Access Compliance Report

Public Rights-of-Way

(Curb Ramps)

Intersection ID: 10034377	Main Street: CAMERON_VALLEY_PY	Cross Street: PHILLIPS_PL	Location: SW
ADA ID: D0D78CD20C64	Ramp Type: BlendTrans1	Initial Pass/Fail: Fail	Overall Compliance: No
		Severity Score: 1.25

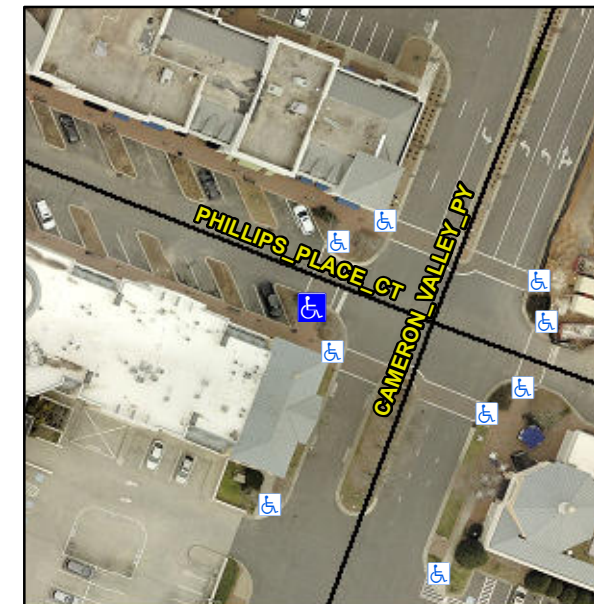
Surveyor Notes:

XWALK PAVERS

PROW/ADA:

R304.5.3

Compliance	Description	Data	Compliance	Description	Data
N/A	Ramp Length (in)	48.0	Yes	BlendTrans Slope (%)	1.6
Yes	Ramp Width (in)	48.0	No	BlendTrans XSlope (%)	4.7
N/A	Flare Type LT	N/A	N/A	Flare Type RT	N/A
N/A	Flare Slope LT (%)	N/A	N/A	Flare Slope RT (%)	N/A
N/A	Flare Traversable LT?	N/A	N/A	Flare Traversable RT?	N/A
N/A	Landing Length (in)	N/A	N/A	DWS Provided?	N/A
N/A	Landing Width (in)	N/A	N/A	DWS Contrast?	N/A
N/A	Landing Slope (%)	N/A	N/A	DWS Length (in)	N/A
N/A	Landing X Slope (%)	N/A	N/A	DWS Full Width?	N/A
N/A	Landing Curb? (Y/N)	N/A	N/A	DWS Offset (in)	N/A
N/A	Shared Landing?	N/A			
N/A	Gutter Ponding?	N/A	N/A	Gutter Slope (%)	N/A
N/A	Gutter Lip Ht (in)	N/A	N/A	Gutter X Slope (%)	N/A
N/A	Painted X Walk1?	Yes	N/A	Painted X Walk2?	N/A
	X Walk 1 Direction	To NW		X Walk 2 Direction	N/A
	X Walk 1 Width (in)	170.0		X Walk 2 Width (in)	N/A
	X Walk 1 Slope (%)	0.9		X Walk 2 Slope (%)	N/A
	X Walk 1 X Slope (%)	2.8		X Walk 2 X Slope (%)	N/A

Possible Solutions:

Remove & Replace Curb Ramp With Two New Directional Ramps or Equivalent.
